SOLDIERS POINT - RED LINE DRAWINGS

SHOREHAM ADUR TIDAL WALLS
W1 SOLDIERS POINT
REMEDIAL WORKS

CONSTRUCTION SEQUENCE AND SITE CONTRAINTS

Drawing No: 10785-RAM-XX-XX-DR-CW-0005 Rev: RL02

PLAN -
1: 300 -

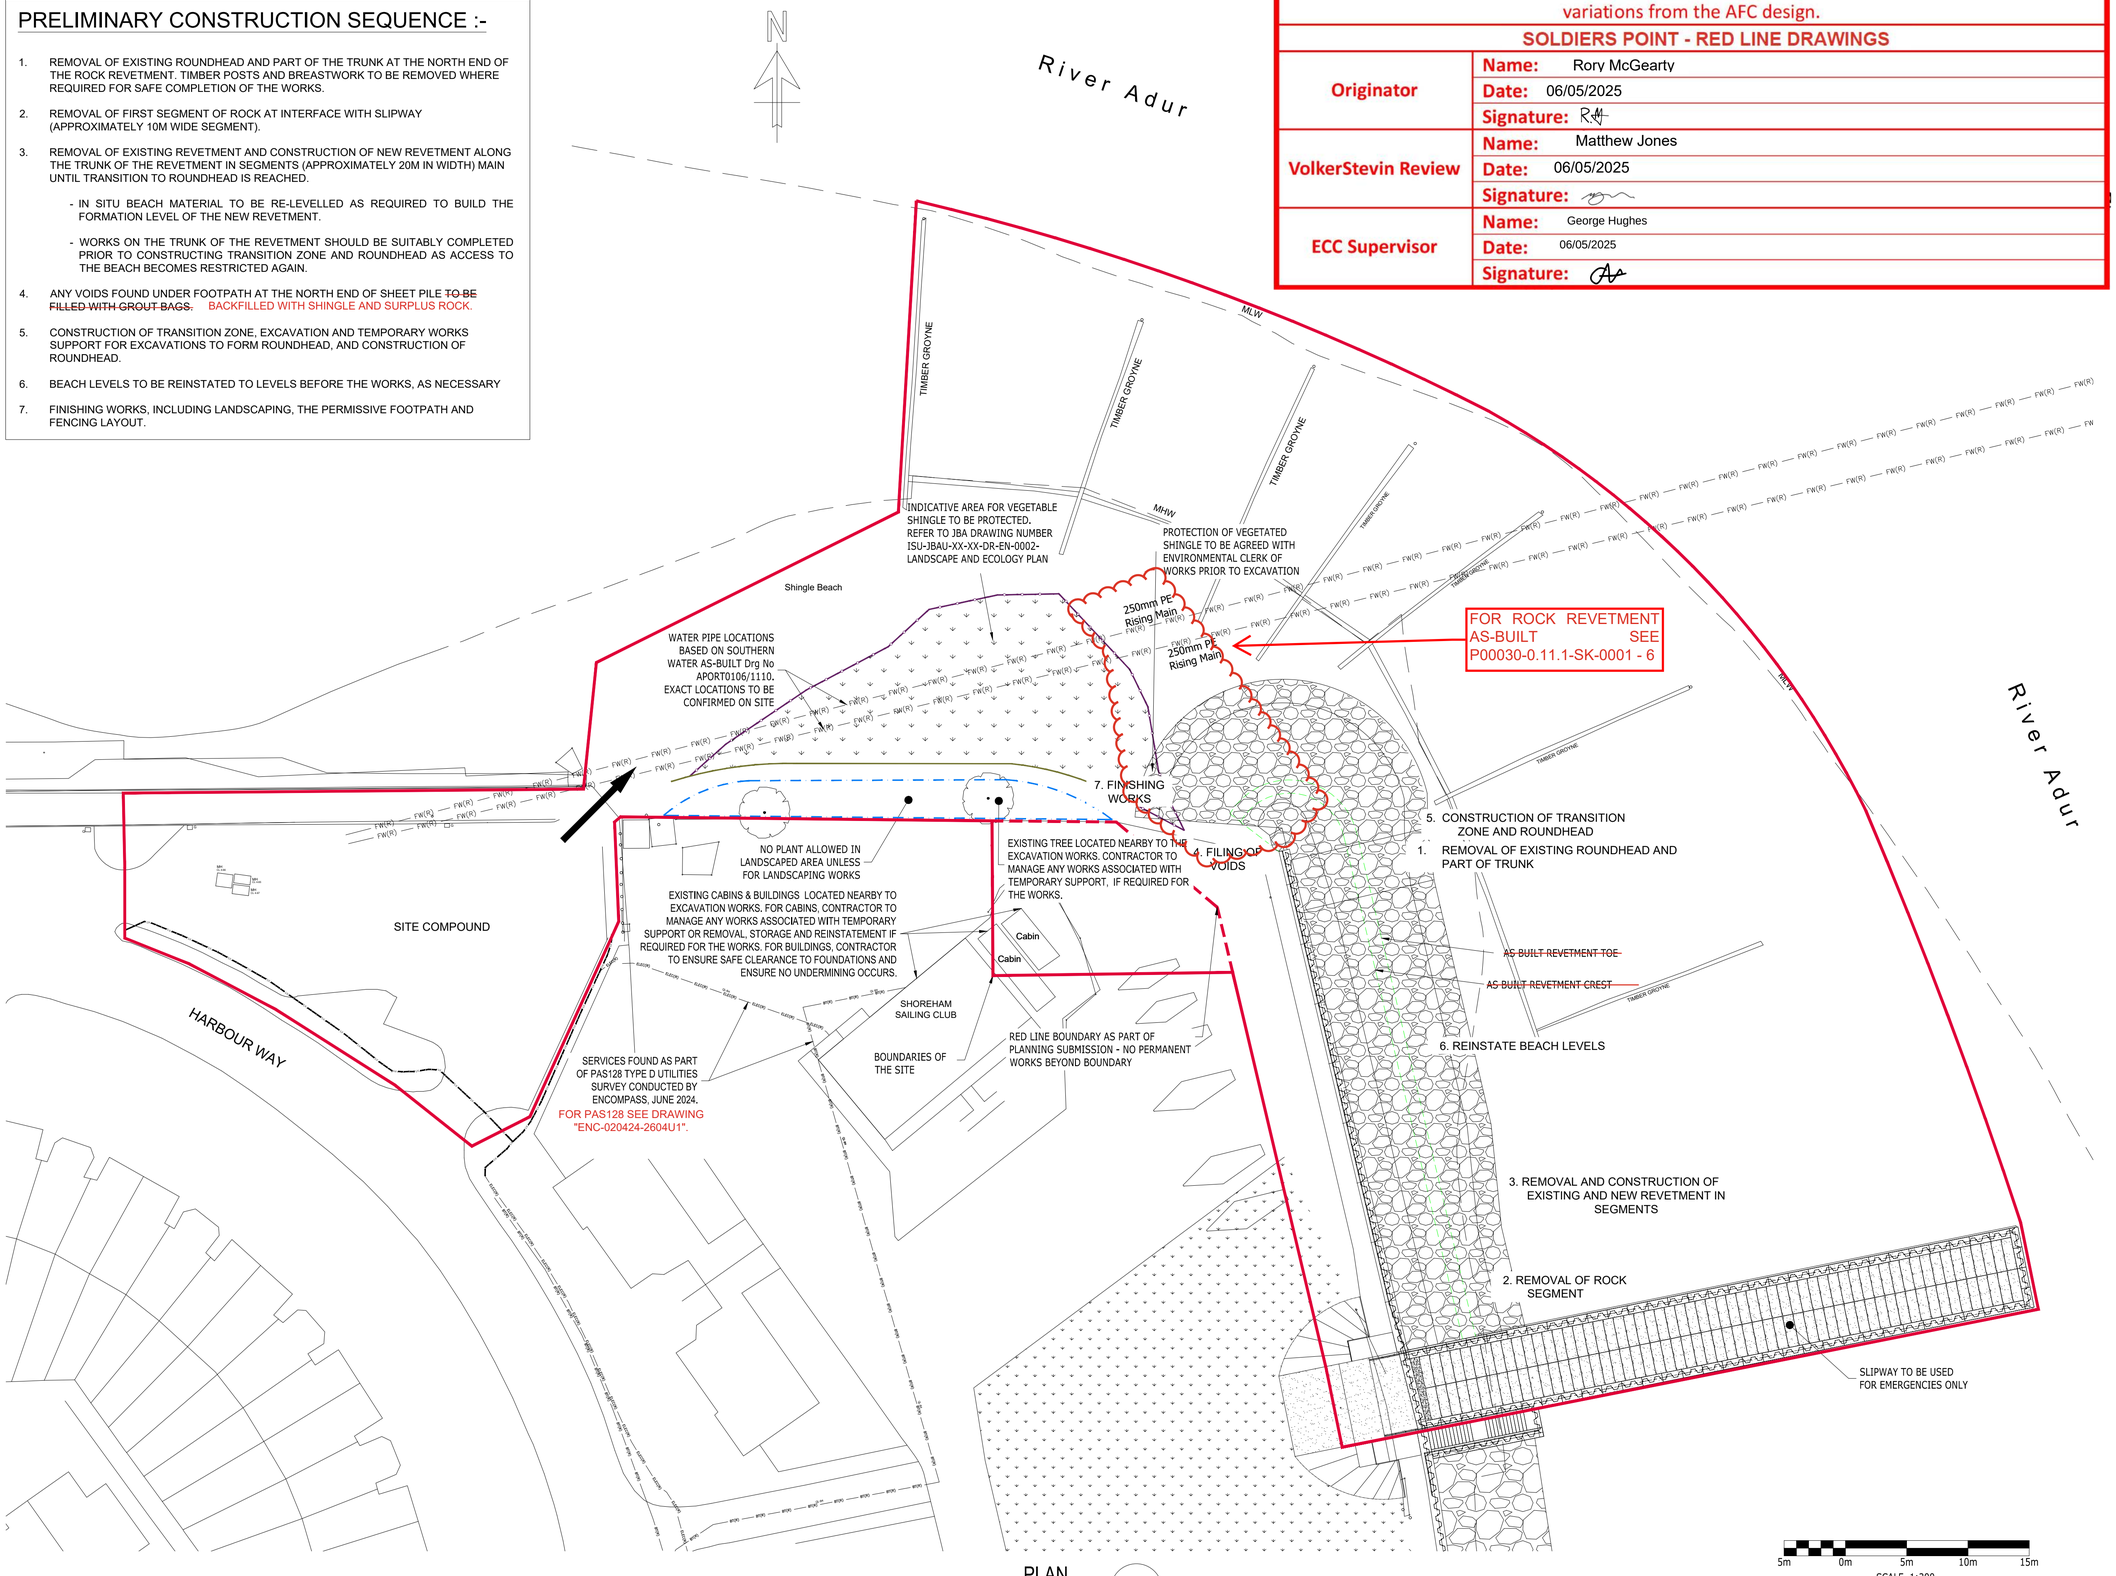
4. ANY VOIDS FOUND UNDER FOOTPATH AT THE NORTH END OF SHEET PILE ~~TO BE FILLED WITH GROUT BAGS.~~ BACKFILLED WITH SHINGLE AND SURPLUS ROCK.
5. CONSTRUCTION OF TRANSITION ZONE, EXCAVATION AND TEMPORARY WORKS SUPPORT FOR EXCAVATIONS TO FORM ROUNDHEAD, AND CONSTRUCTION OF ROUNDHEAD.
